SERVICE INFORMATION NO. SI-40-115

GARMIN Service Bulletin 0823 Revision C
ATA-Code: 34-00

**** MANDATORY ****
SERVICE BULLETIN
NO.: 0823 Rev C

SUBJECT: GDU 104X CRS/BARO Knob Interference

Figure 1

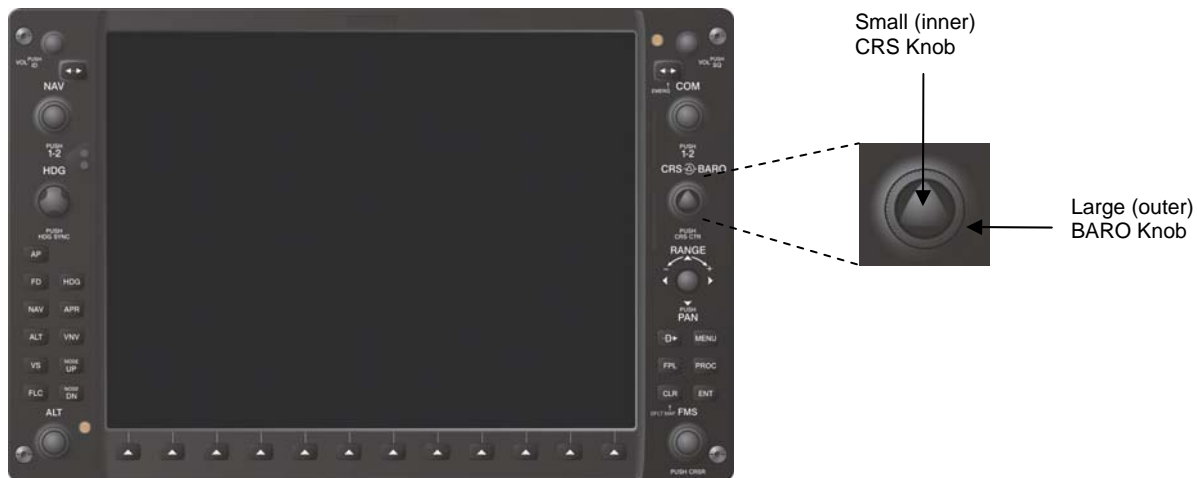
Garmin has identified an issue, whereby the large (outer) BARO knob and the small (inner) CRS knob may interfere with each other.

1. Apply power to the G1000/G900X/G950.
2. Press the CDI softkey on the Primary Flight Display(s) (PFD) to enter VOR mode on the HSI.
3. Rotate the large (outer) BARO knob (refer to Figure 1) a minimum of three complete revolutions in each direction while monitoring the Horizontal Situation Indicator/Digital Course Indicator (refer to Figure 3) on the PFD. If a change in the Horizontal Situation Indicator/Digital Course Indicator is produced while turning the BARO knob proceed to the Modification Instructions.

4. Rotate the small (inner) CRS knob (refer to Figure 1) a minimum of three complete revolutions in each direction while monitoring the Barometric Altimeter Setting (refer to Figure 3) on the PFD. If a change in the Barometric Altimeter Setting is produced while turning the CRS knob proceed to the Modification Instructions.
5. Repeat Steps 3 and 4 for each affected GDU.

1. Grasp the small (inner) CRS knob and firmly pull the knob off the shaft.
2. Discard knob.
3. Grasp the large (outer) BARO knob and firmly pull the knob off the shaft.
4. Discard knob.

5. Grasp the large (outer) BARO knob (insuring proper orientation) and place it over the shaft.
6. Align the flat side of the knob insert with the flat side of the shaft.
7. Press down firmly to ensure knob is completely seated, refer to Figure 4.
8. Grasp the small (inner) CRS knob (insuring proper orientation) and place it over the shaft.
9. Align the flat side of the knob insert with the flat side of the shaft.
10. Press down firmly to ensure knob is completely seated, refer to Figure 4.
11. Perform the CRS/BARO Knob Interference Test (contained in the TESTING PROCEDURE section) again to confirm there is no interference.
12. Accomplish aircraft logbook entry to return aircraft to service in compliance with this service bulletin.

Figure 2

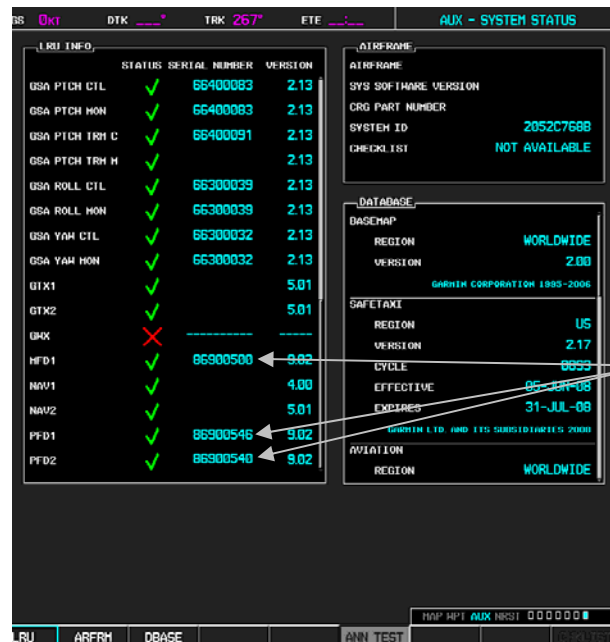
GDU 104X installations with GDU software version 3.02 and later can view unit serial numbers on the AUX – SYSTEM STATUS page. Refer to Figure 2 for an example.

If the GDU 104X serial number on the AUX – SYSTEM STAUS page displays “0” or if the GDU software version does not display the unit serial numbers, remove the GDU and verify the serial number on the serial number tag.
